**[Docket No. FAA-2025-2546; Project Identifier AD-2025-01060-T]**

#### **Airworthiness Directives; The Boeing Company Airplanes**

**ACTION:** Notice of proposed rulemaking (NPRM).

**Figure 2 to paragraph (i) – Fuel Feed Encapsulation**

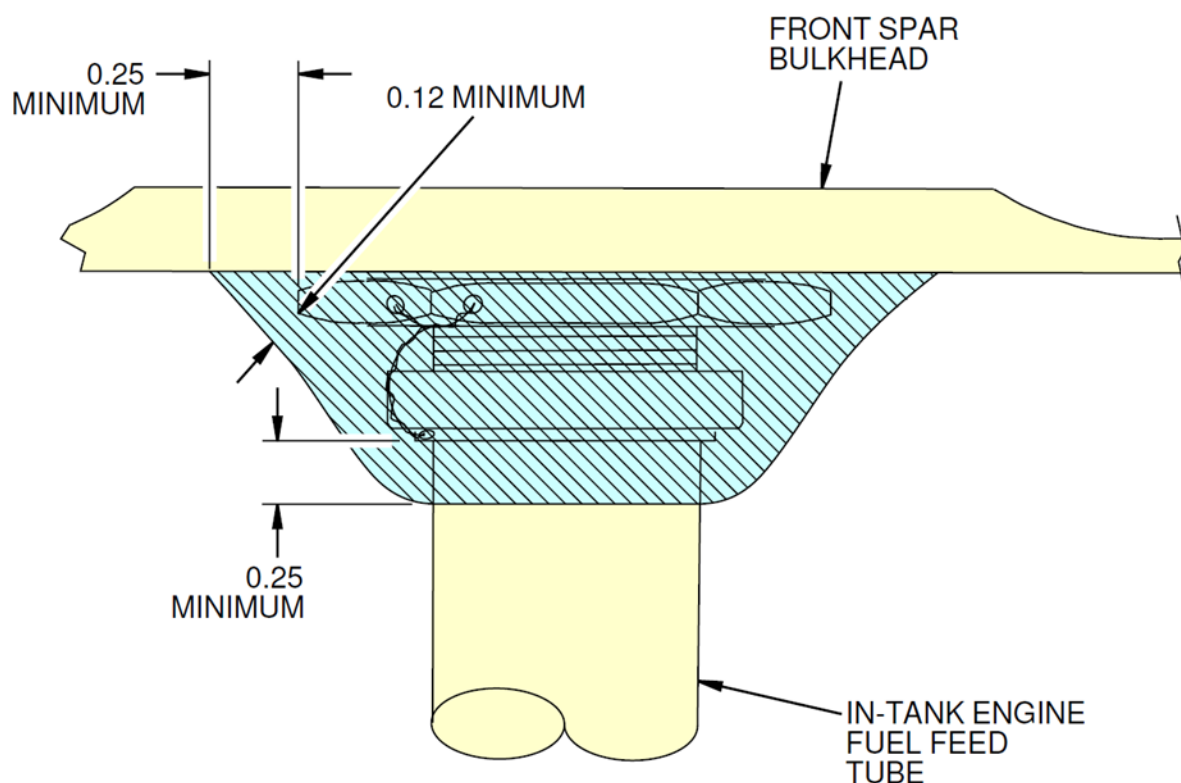
Within 60 days after the effective date of this AD, revise the existing maintenance or inspection program, as applicable, to incorporate the information specified in Figure 1 and Figure 2 to paragraph (i) of this AD.
